GRADING AND EROSION CONTROL PLAN

JUDGE ORR ROAD RV PARK AND STORAGE

EL PASO COUNTY, COLORADO

FIGURE OS-5 TYPICAL OUTLET STRUCTURE WITH WELL SCREEN TRASH RACK

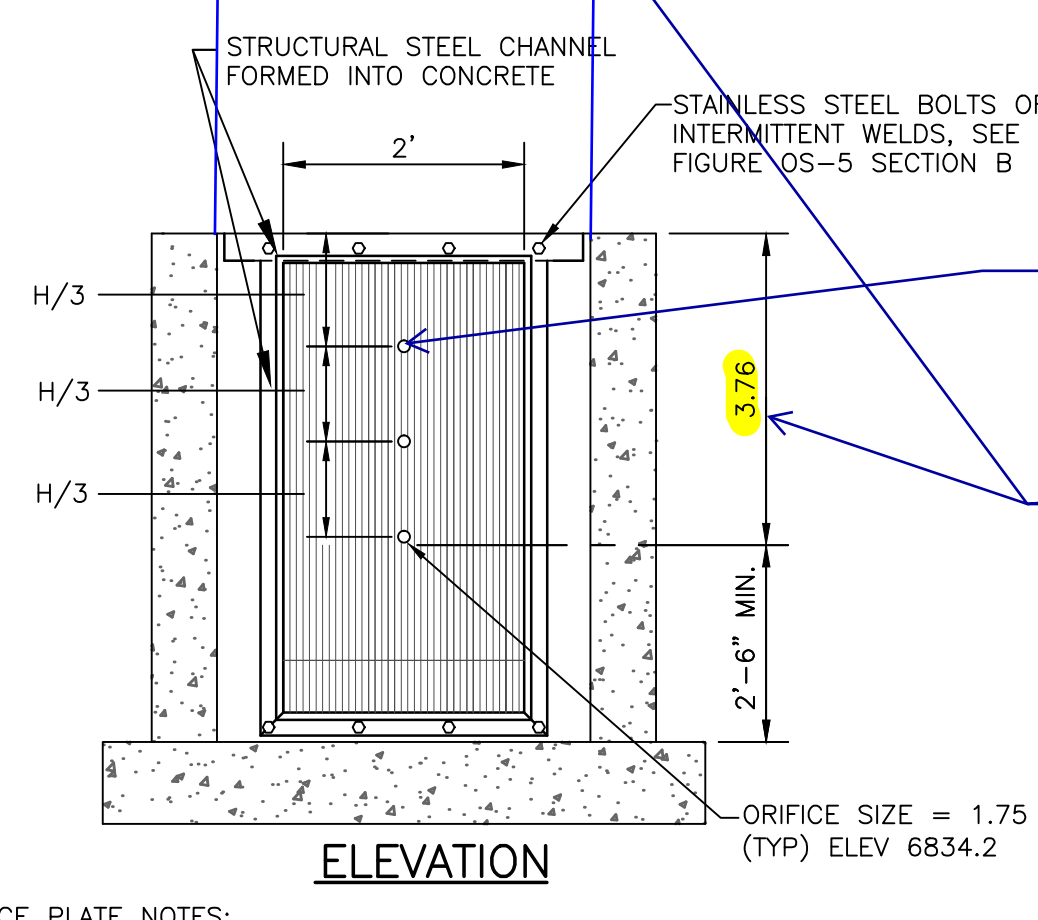
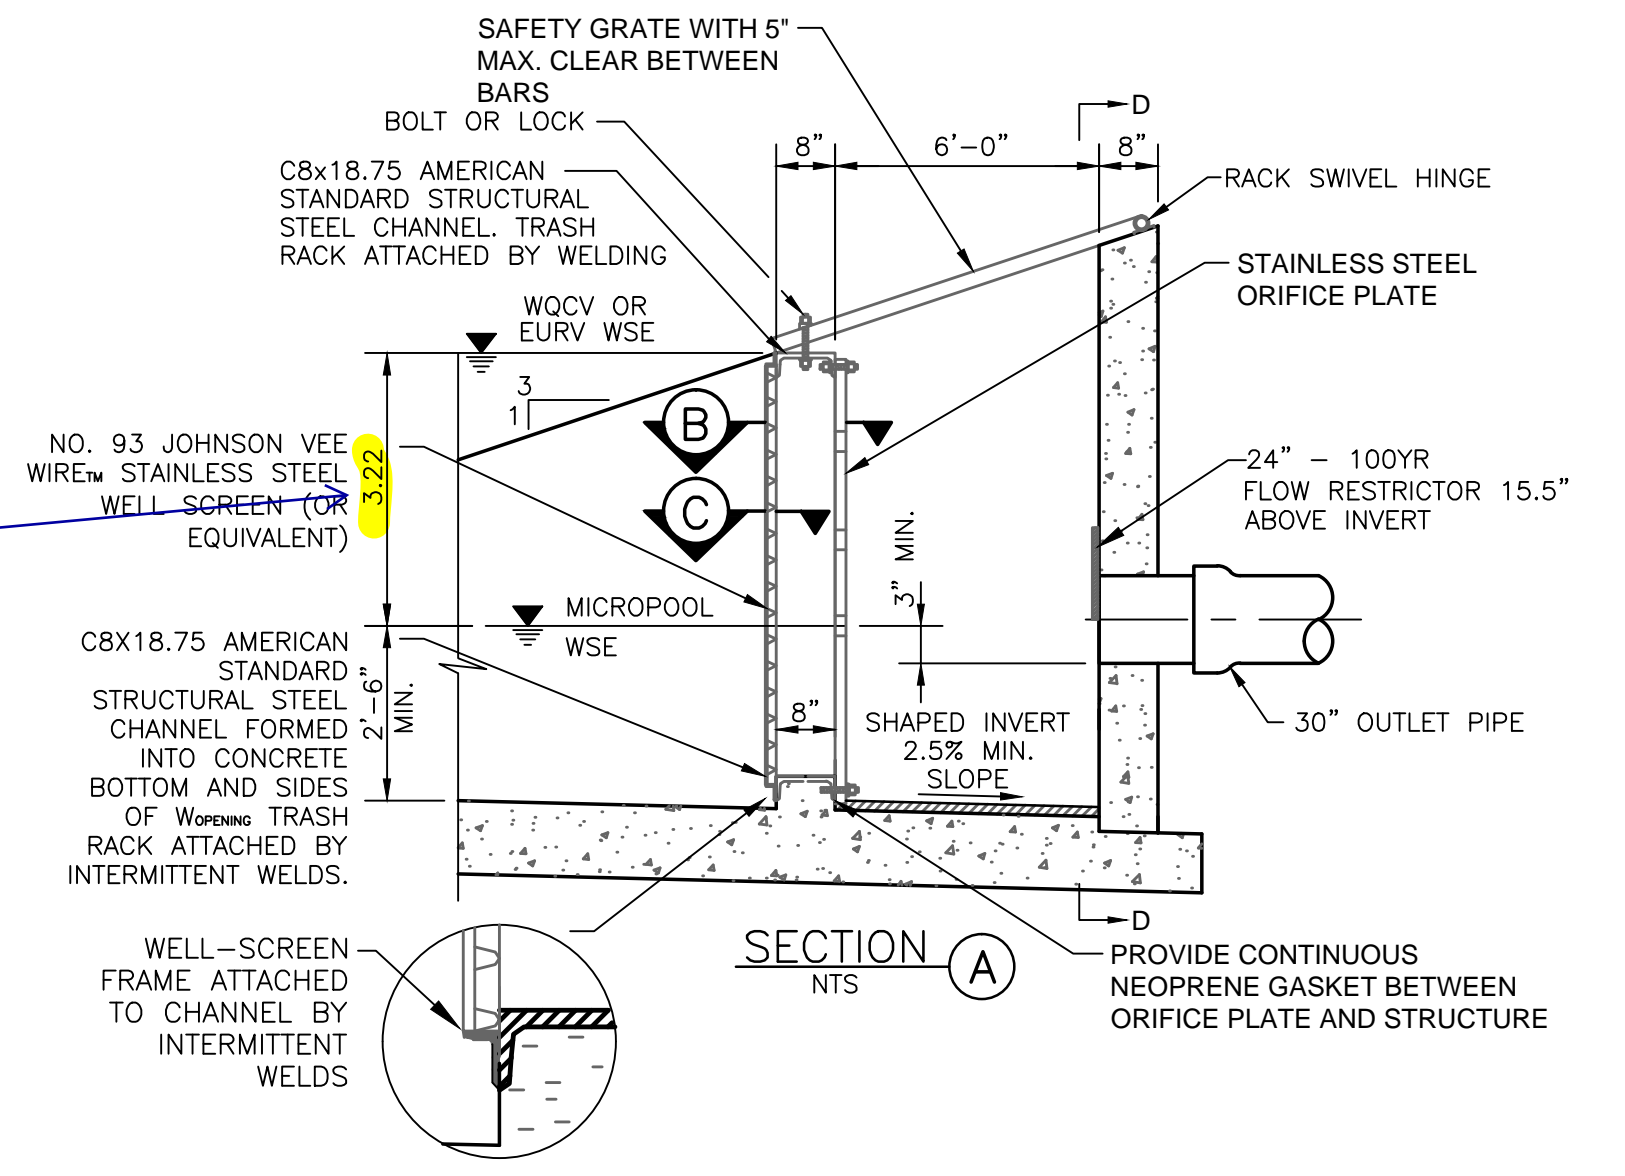
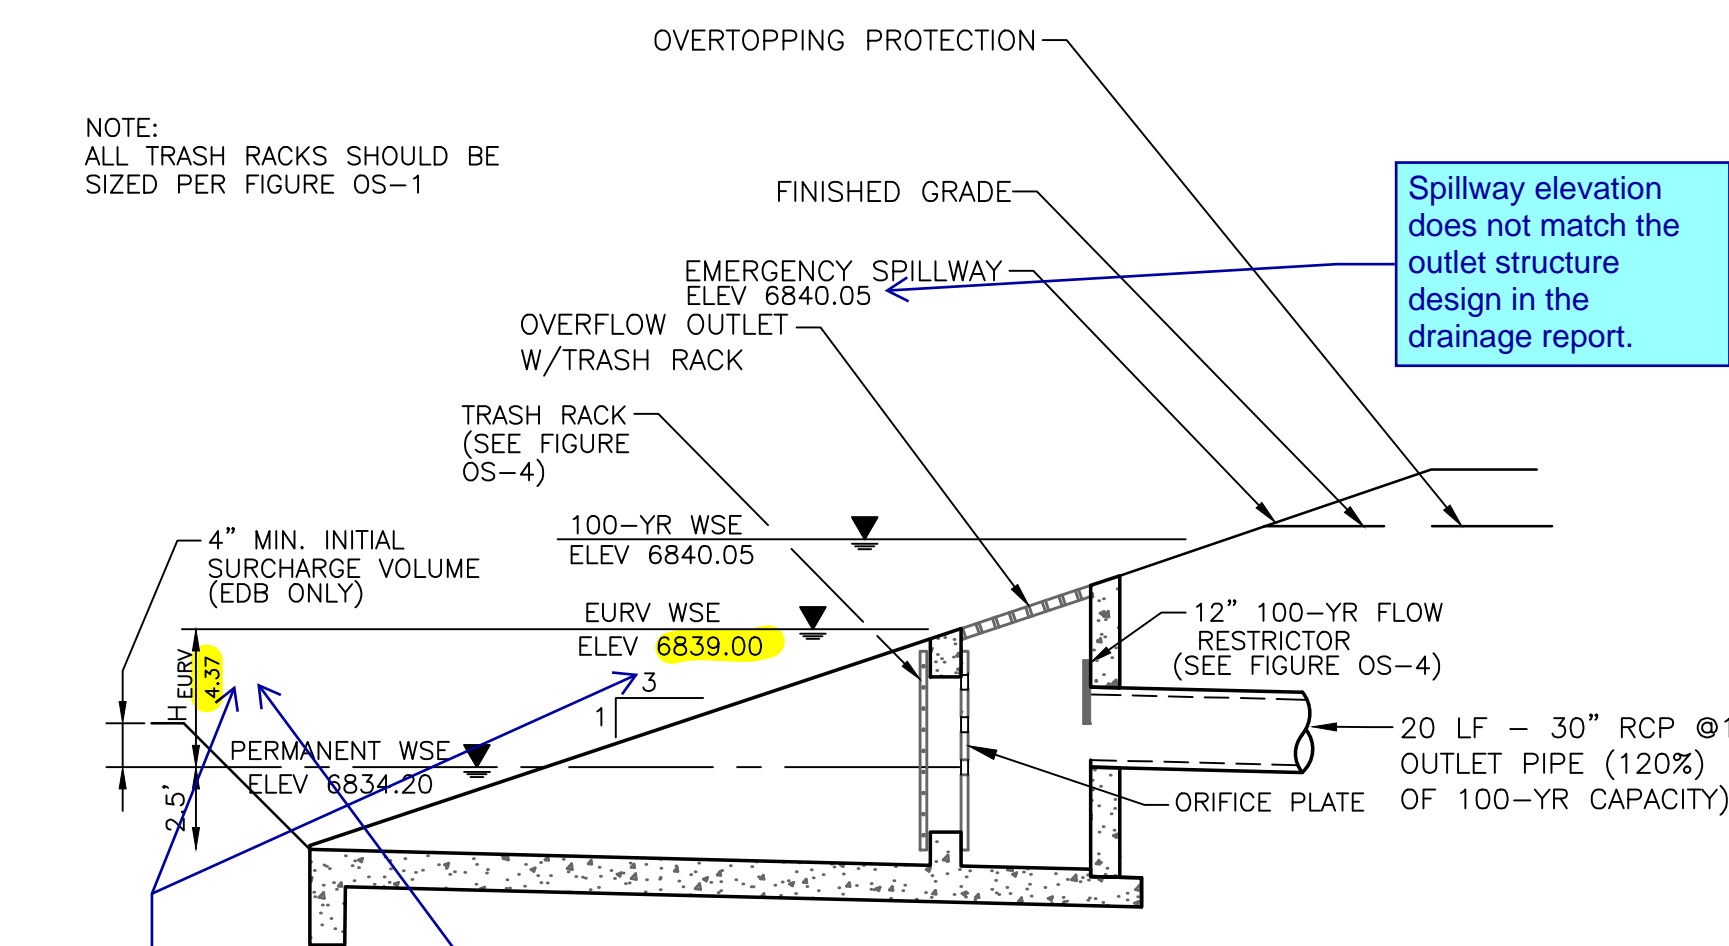
Drainage report calls for a larger diameter. Revise. Height between orifice does not match the outlet structure design in the drainage report. Replace the H/3 with the actual elevation of each orifice centroid. The 3.76 height does not match Fig OS-5 which notes 4.37

See the comment on the FDR UD-Detention worksheet. Design is likely to be revised. Will review with the resubmittal.

Does not match the outlet structure design in the drainage report.

Label the width of the outlet structure

Provide the calculation for the required forebay volume and actual forebay volume and the weir (notch) calculation in the drainage report.

Spillway elevation does not match the outlet structure design in the drainage report.

SEDIMENT BASIN PLAN

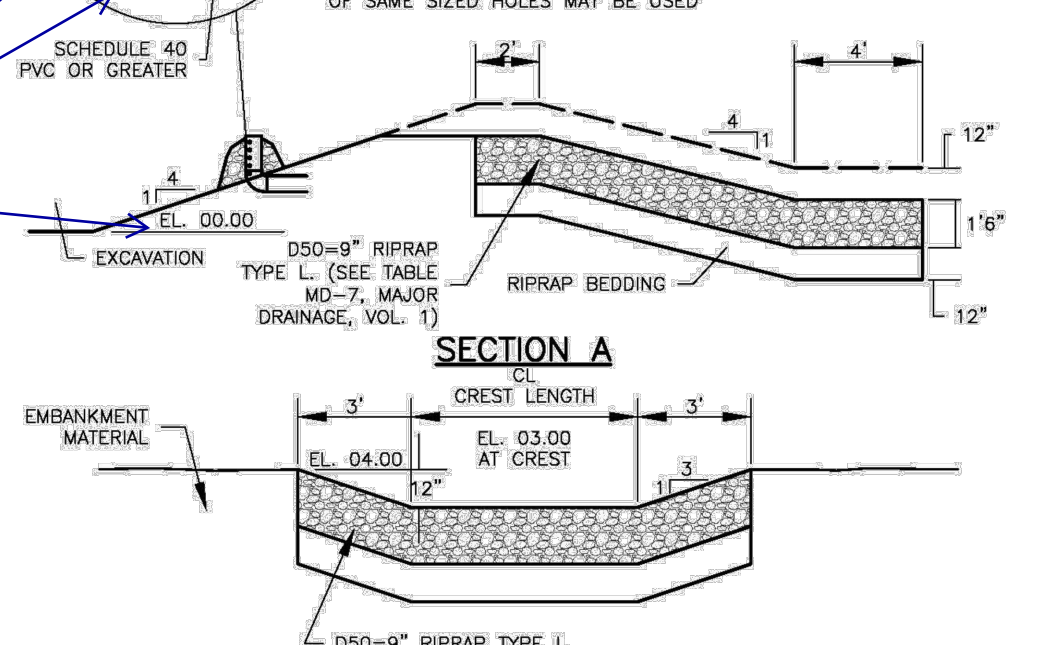
Identify the required temporary sediment basin pond volume. Based on the pond configuration, the relative elevation of 3.00 from the bottom of pond does not appear to provide the required volume.

use actual elevation.
